**PROJECT NOTIFICATION****PROJECT NAME:** North Decatur Transformer #5 Replacement and Relocate**LOCATION:** Oreana (Q33) and North Decatur (Q09) Substations**IN SERVICE DATE:** 6/1/2015**NOTIFICATION:** Revision 1**COMPANY:** AIC**MAP ID#:** N/A**ISP:** D66046**DIVISION:** 3**DP** 11127**SACF** = 27.10**DESCRIPTION & SCOPE:**

**PROJECT NOTIFICATION**  
 < Div 3 – North Decatur Transformer #5 Replacement and Relocate >  
 (DP 11127)

**Revision 1 Changes:**

Oreana Sub Partial One Line:

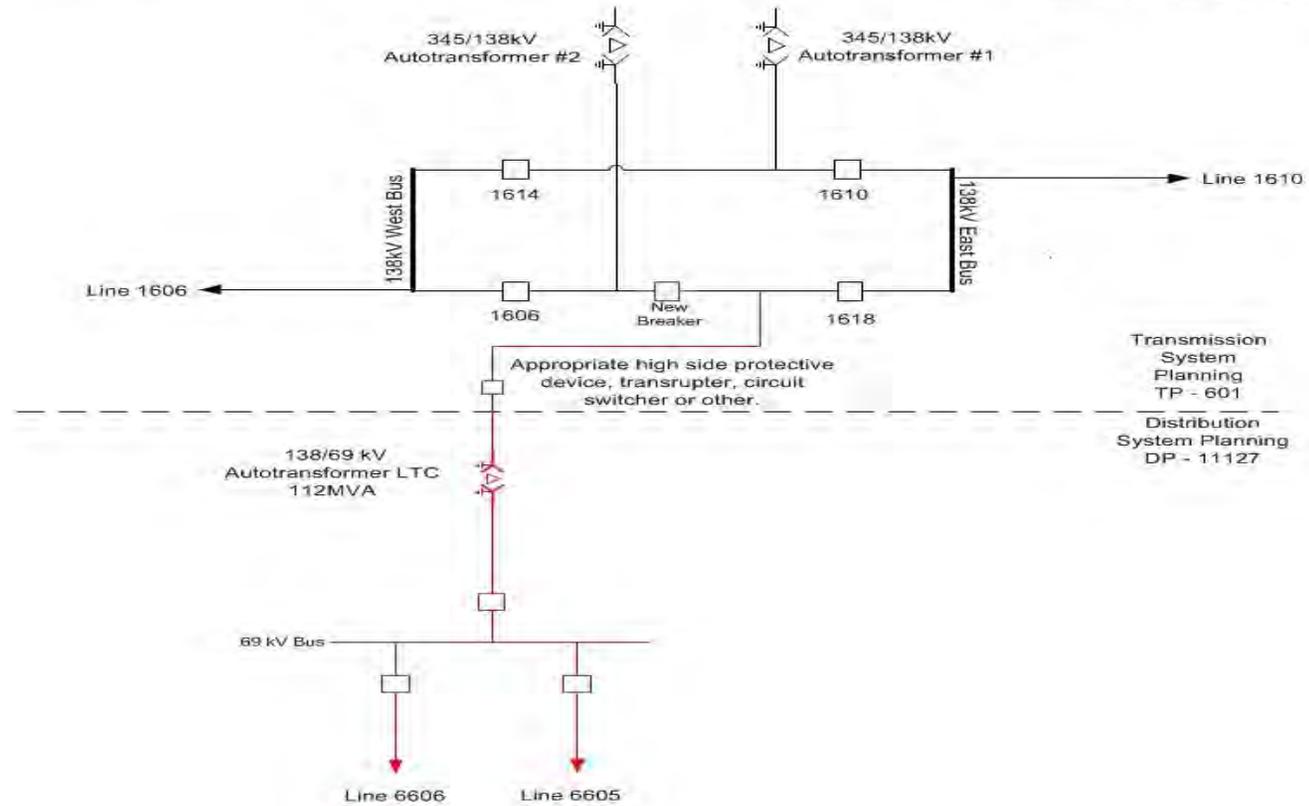
1. Replace and relocate N. Decatur Transformer #5 to Oreana Substation. Transformer will be tapped between breaker 1618 and new 138kV breaker located between breakers 1606 and 1618. See Attachment 1 for the new Oreana 138/69kV transformer specifications.
2. Install a new 69kV bus with two 69kV line terminals for Lines 6605 and 6606.
3. Minimum continuous current-carrying capability of the 69kV breaker and disconnect switches of 1200A.
4. See Attachments 2 and 3 for mark-ups of Oreana related changes.

Partial Decatur (North) System One Line:

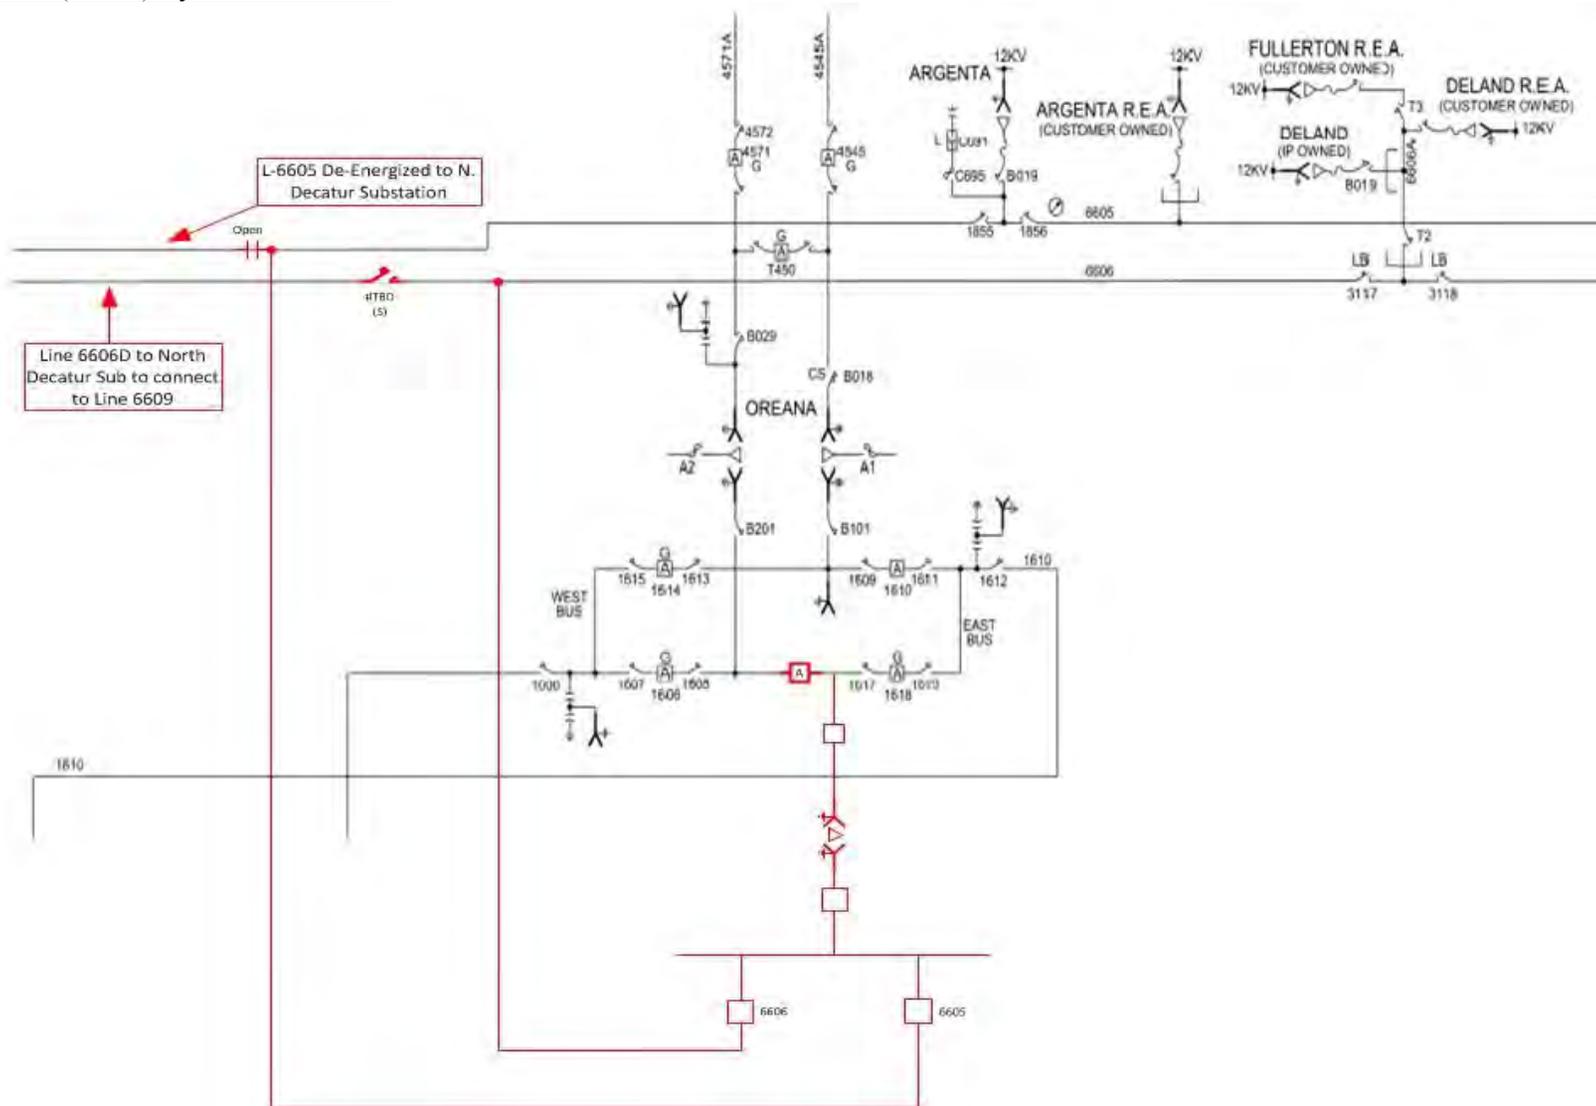
1. Retire and remove all hardware related to N. Decatur Trf #5, the 69kV line terminals for lines 6605, 6606, and 6609, and the 69kV bus work.
2. See Attachments 4 and 5 for mark-ups of North Decatur related changes.

Partial Sections of North Decatur Sub One-Line:

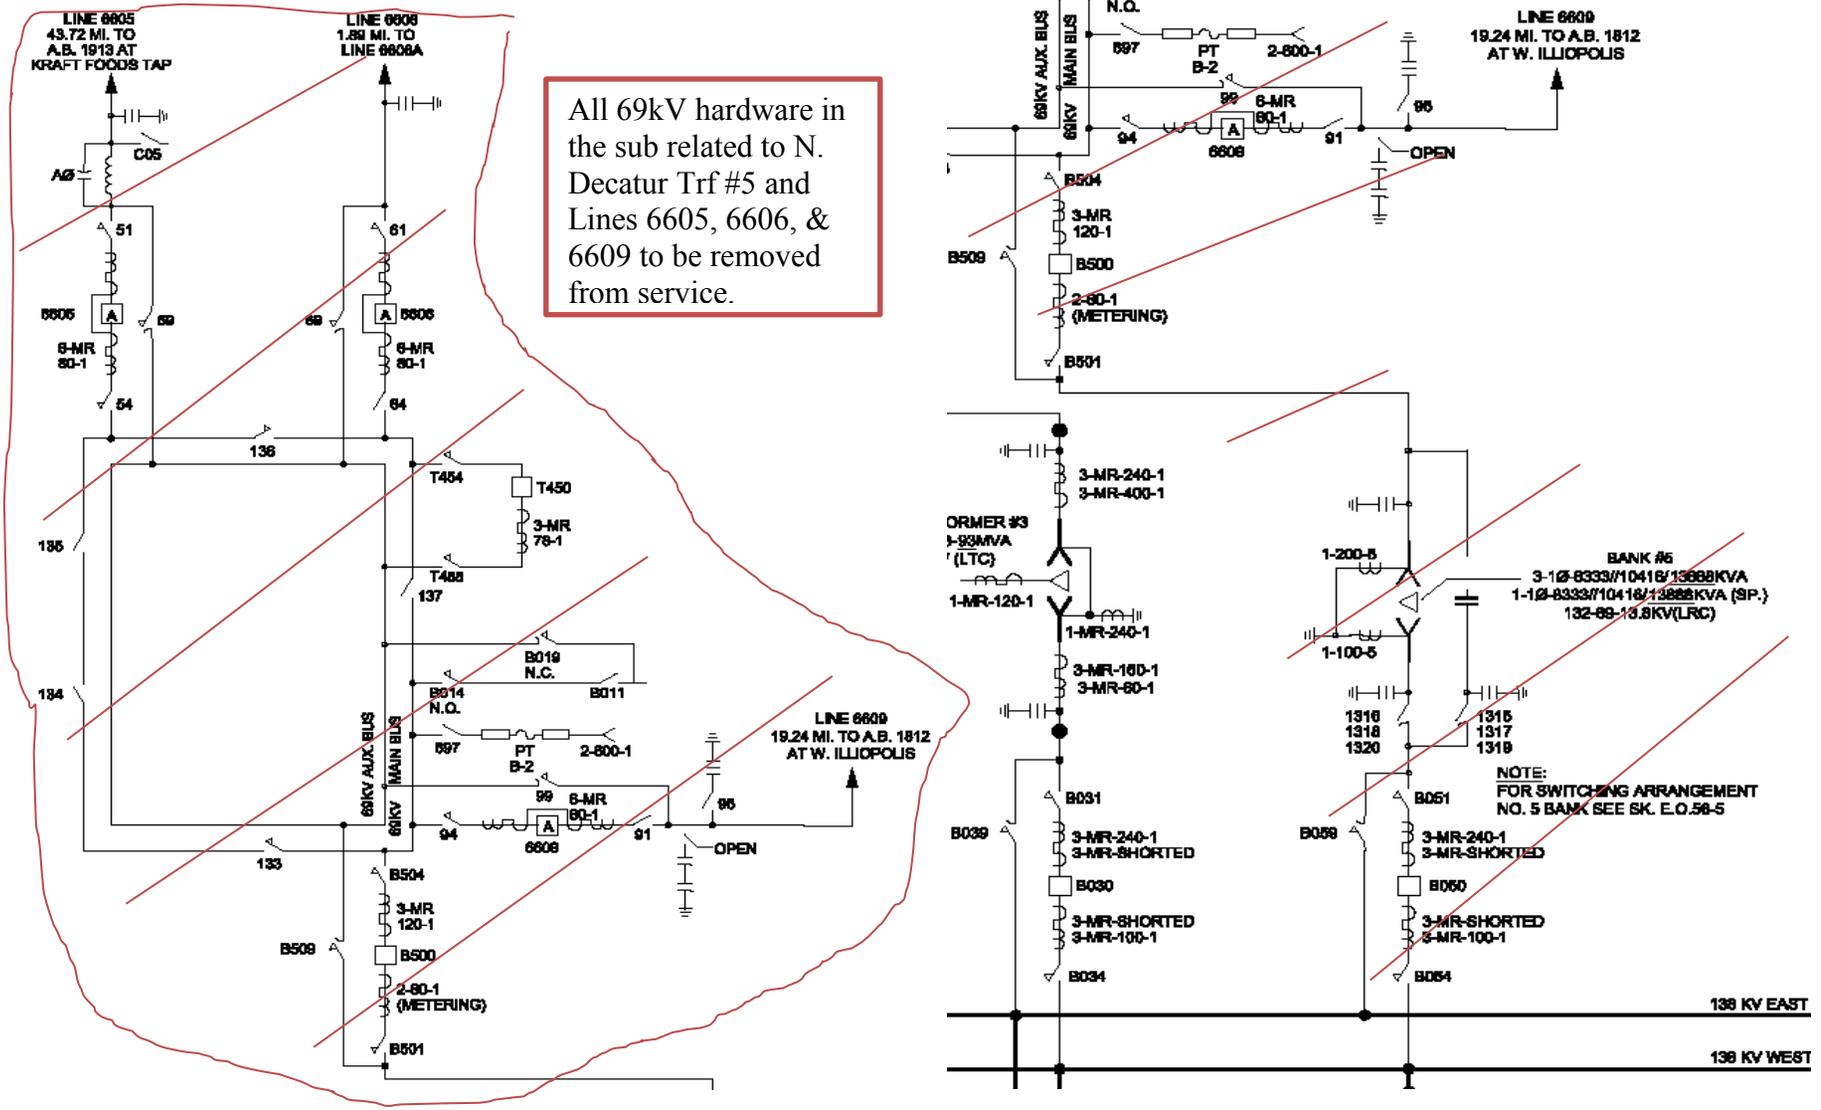
1. The new source for Line 6609 will be Oreana Substation via its tie to Line 6606 outside of the N. Decatur Substation, creating an extended line segment from W. Illiopolis Substation to the new MOAB at Oreana.
2. This combined 6609/6606 line will be called Line 6606D.
3. Fault Indicators to be added to Line 6606D.
4. See attachments 5, 6, & 7 for mark-ups of Line 6609 changes.
